TURNER SENIOR ACADEMY CAMPUS

ADDENDUM 3

10/25/2023

M11.1 SHEET NUMBER:

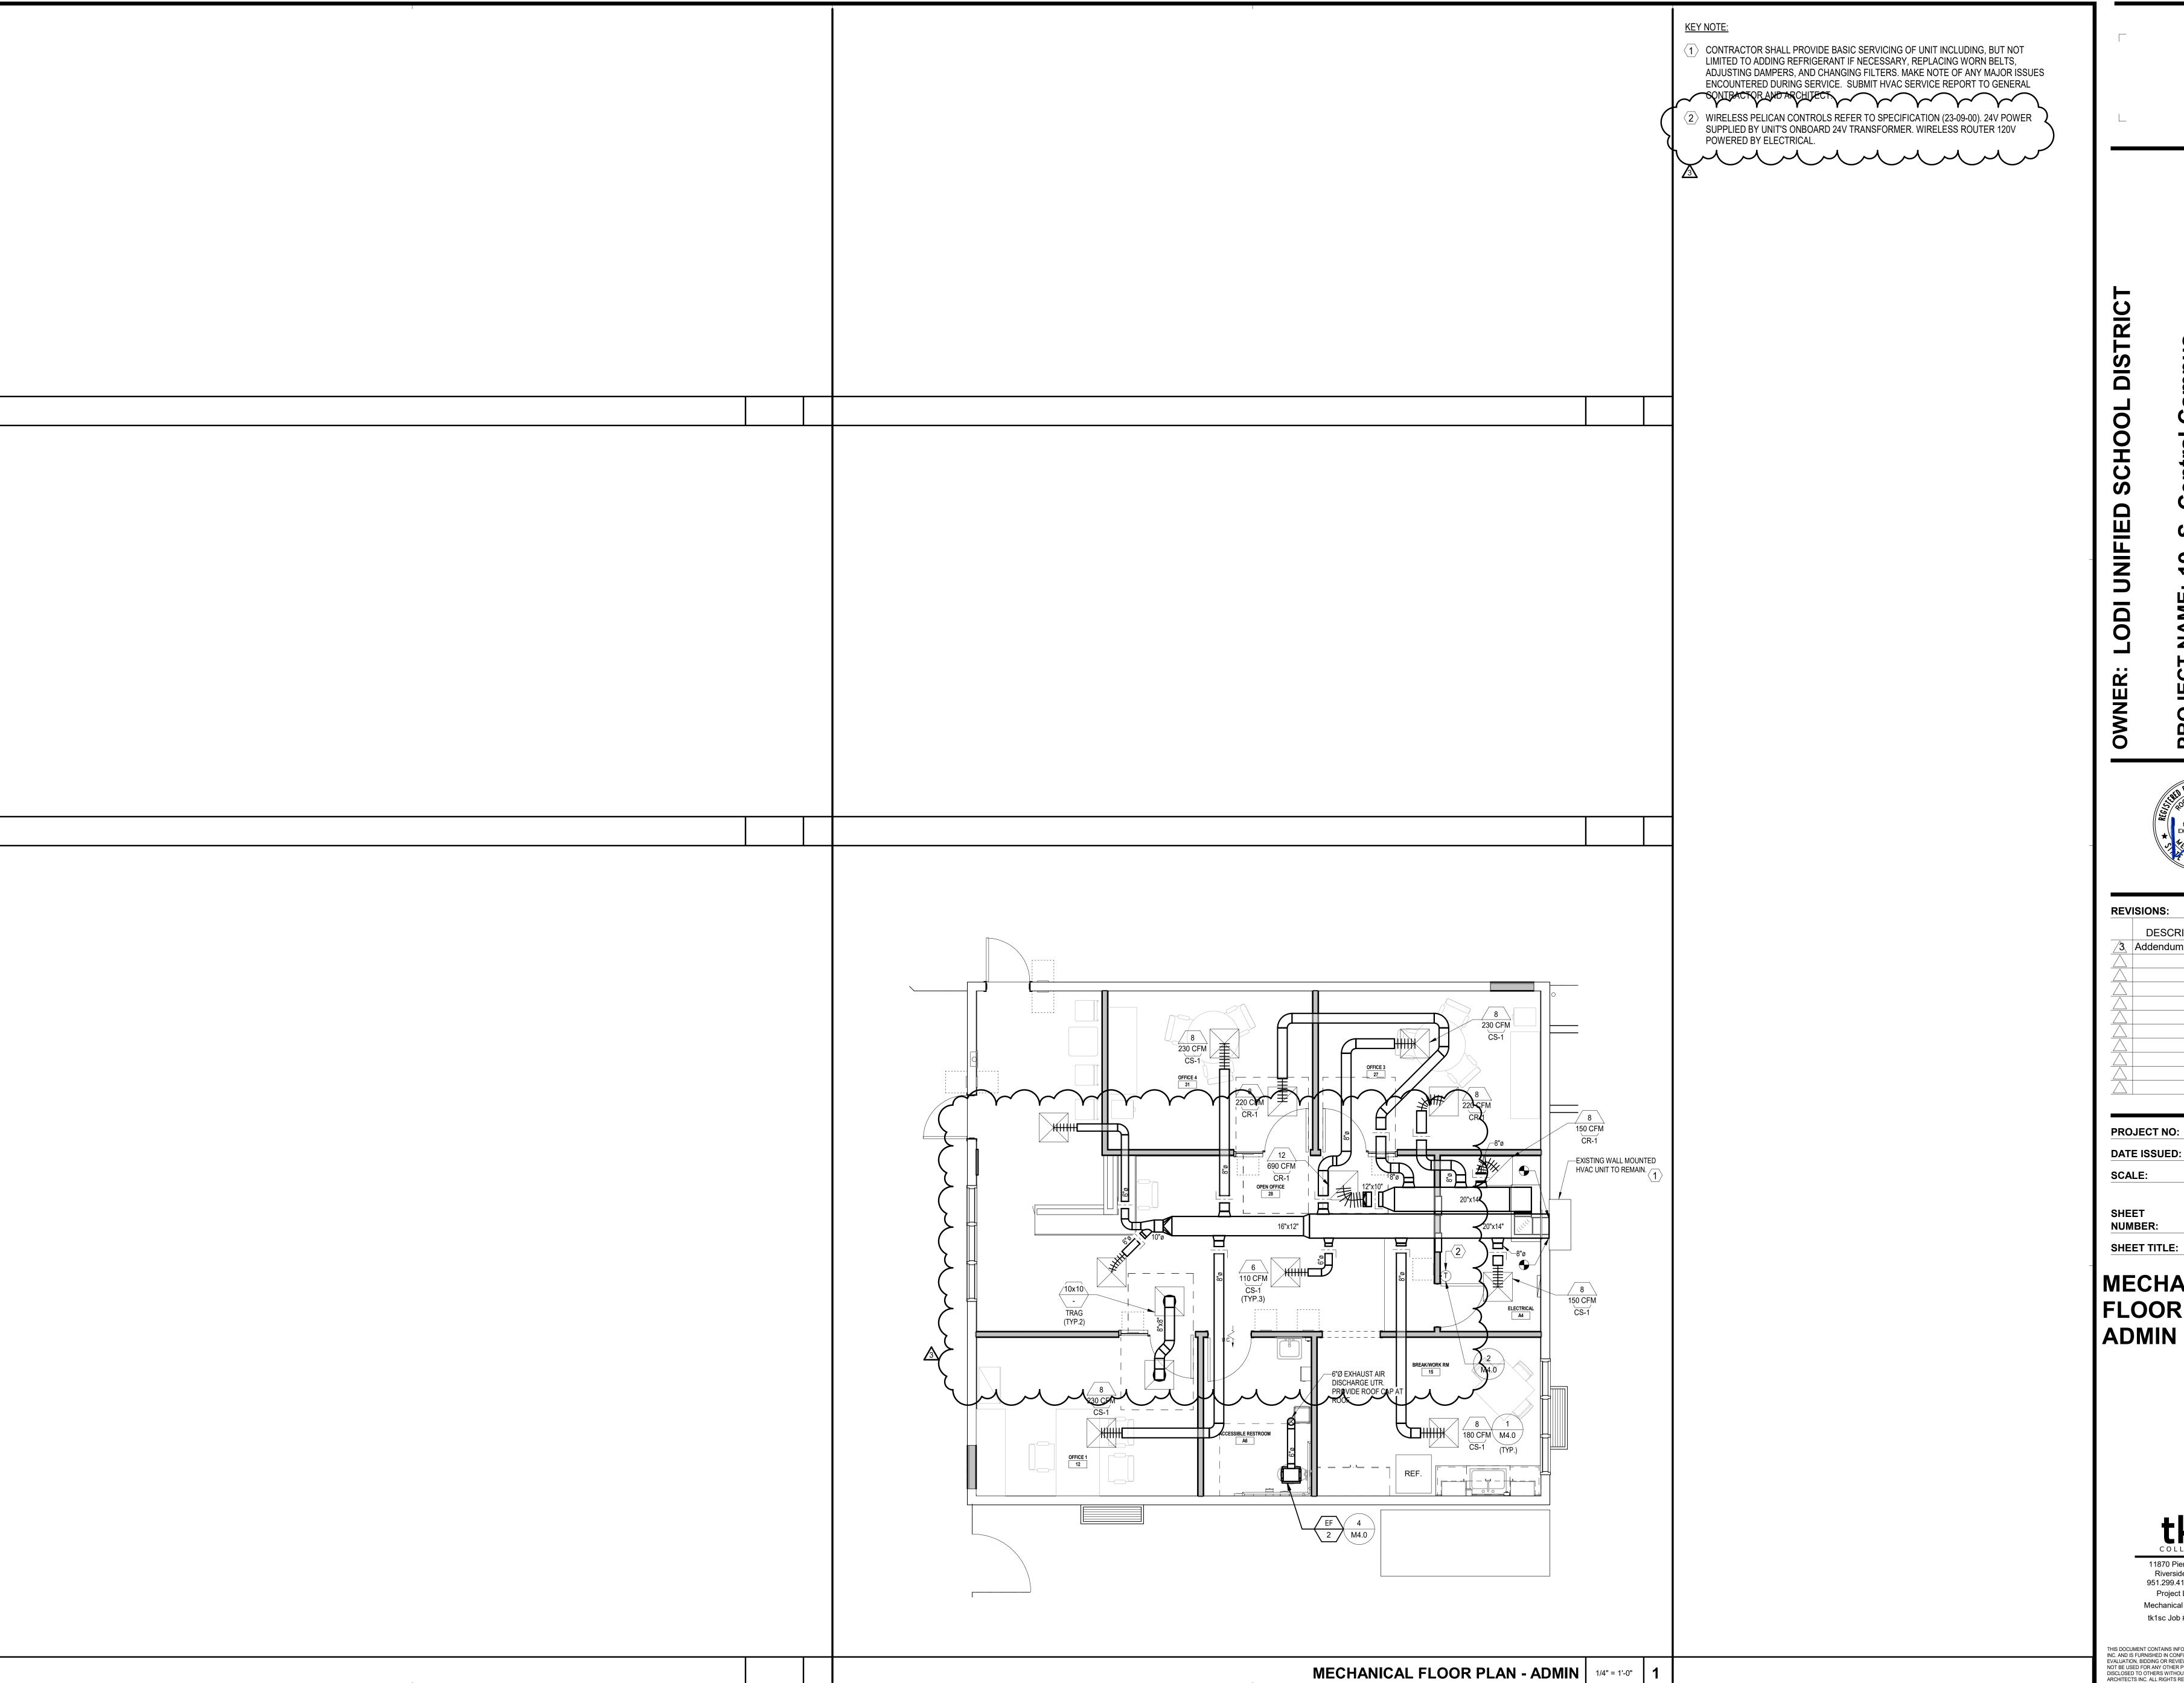
- A. M11.1: Mechanical Floor Plan- Admin (replace previously issued sheet)
  - a. Revised duct layout to accommodate existing structural openings.
  - b. Added Pelican wireless controls.
- B. M11.2: Mechanical Floor Plan- Student Support Services (replace previously issued sheet)
  - a. Added Pelican wireless controls.

E1.0 SHEET NUMBER: SHEET TITLE:

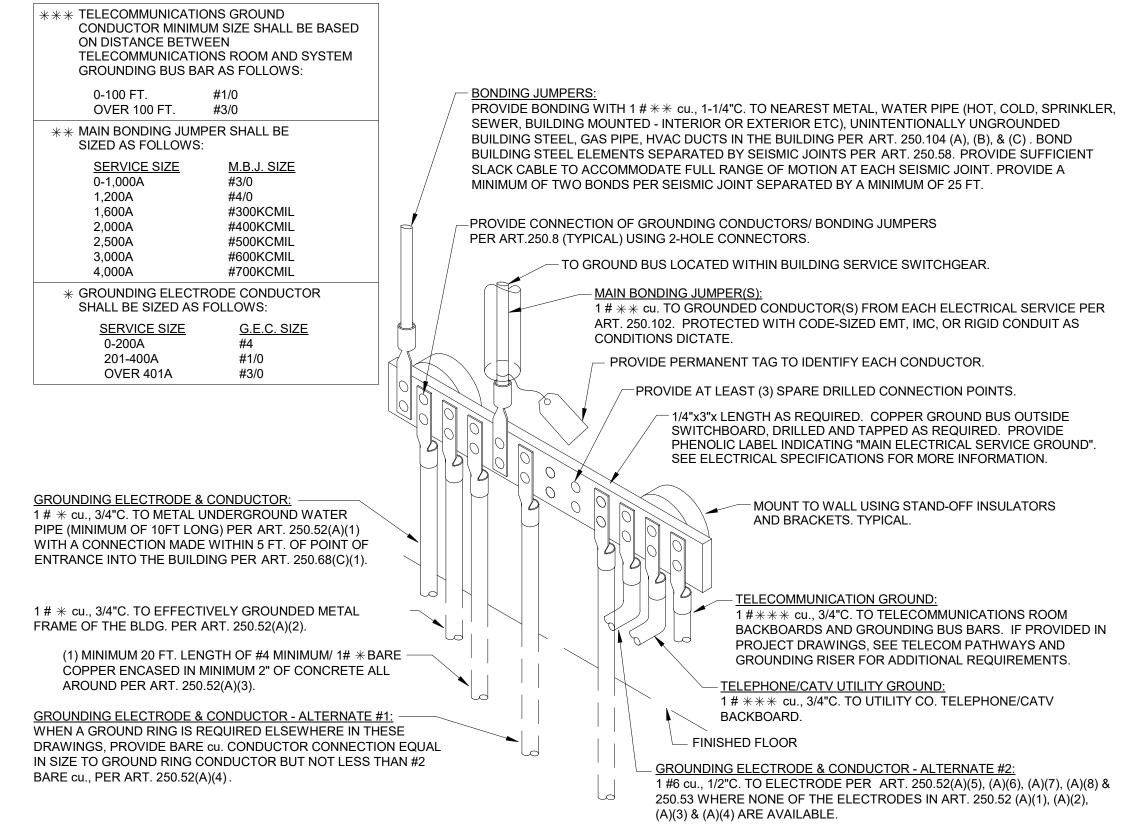
- A. E1.0: Electrical Site Plan (replace previously issued sheet)
  - a. Remove keynote 1.001
  - b. Revised keynote 1.002, and 1.003 and 1.009
  - c. Revised Electrical Site Plan to modify keynotes
  - d. Remove conduit run for future building in parking lot
- B. E4.0: Electrical Single Line Diagram (replace previously issued sheet)
  - a. Revised Feeder schedule
  - b. Changed main switchboard MSB1 to 1200 Amps
  - c. Changed SCC rating to 65,000 Amps
  - d. Changed available fault current to 42,000 Amps
  - e. Changed main circuit breaker to 1200 Amps and removed ground fault protection
  - f. Changed utility transformer to show existing
  - g. Remove feeder MSB1-13 from Feeder Schedule
